From: Hambrick, Gordon A SAJ [Gordon.A.Hambrick@usace.army.mil]
Sent: Friday, July 29, 2011 2:24 PM
To: Bruner, Douglas
Subject: RE: PEF PowerPoint Presentation - Part 2 (UNCLASSIFIED)
Attachments: Part 2 - Slides for PEF USACE Presentation 07282011 v2.pptx

USACE Comments on Differences Between 3 Layers vs. 5 Layers in the Models

USACE Comments on Use of No-Flow Conditions to Represent Brackish Water

EXHIBIT 6
Simulated Cumulative SAS and UFA Drawdown, ft; 1 year; 1.58 mgd

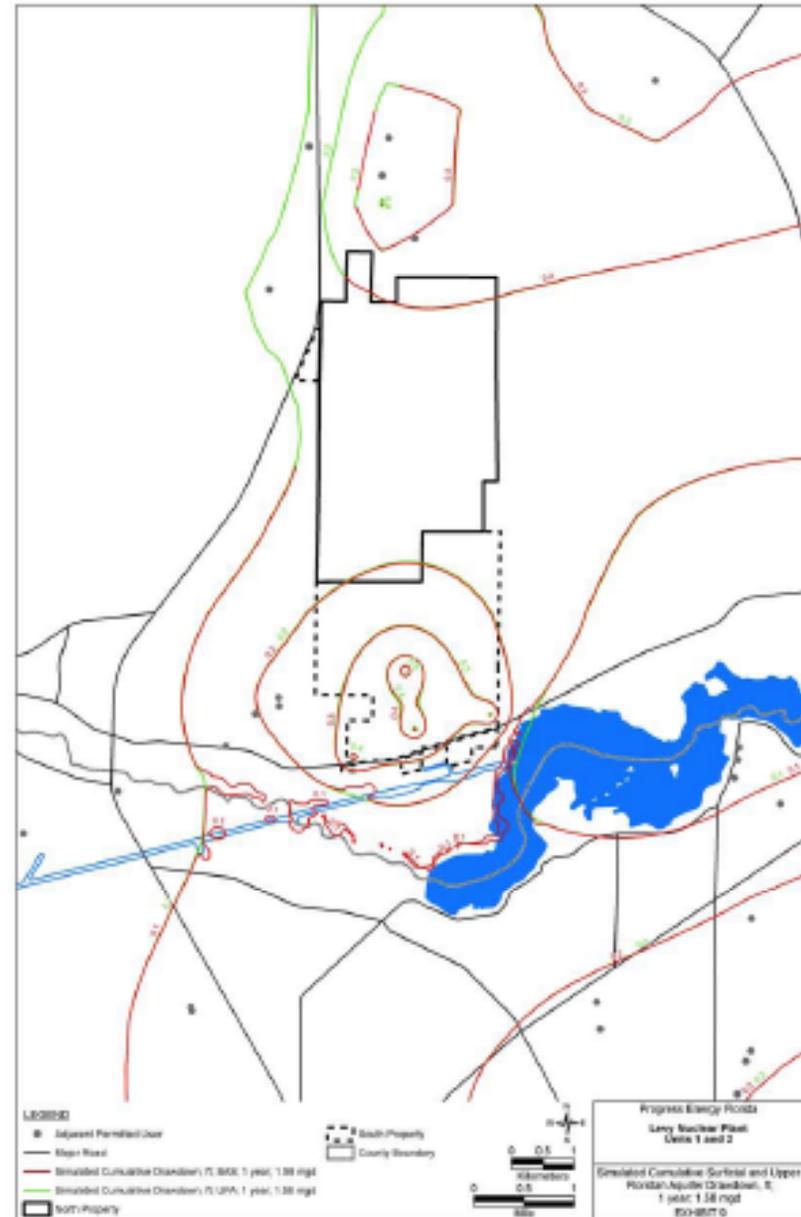
SAS and UFA Regional Drawdown after 1 yr

The SAS and UFA water levels are identical after one year of pumping demonstrating that the intermediate model layers do not influence vertical flow

EXHIBIT 8
Simulated Incremental SAS and UFA Drawdown, ft; 60 years; 1.58 mgd

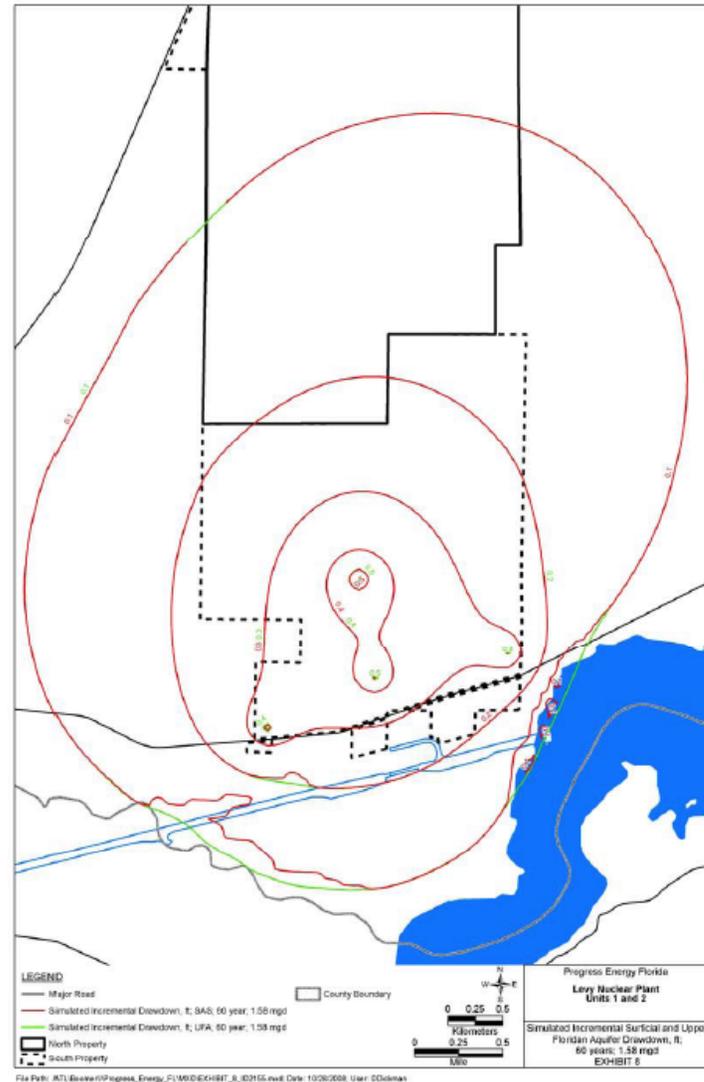
SAS and UFA Regional Drawdown Virtually Identical after 60 yrs

The SAS and UFA water levels are identical after 60 yrs of pumping demonstrating that the intermediate model layers do not influence vertical flow
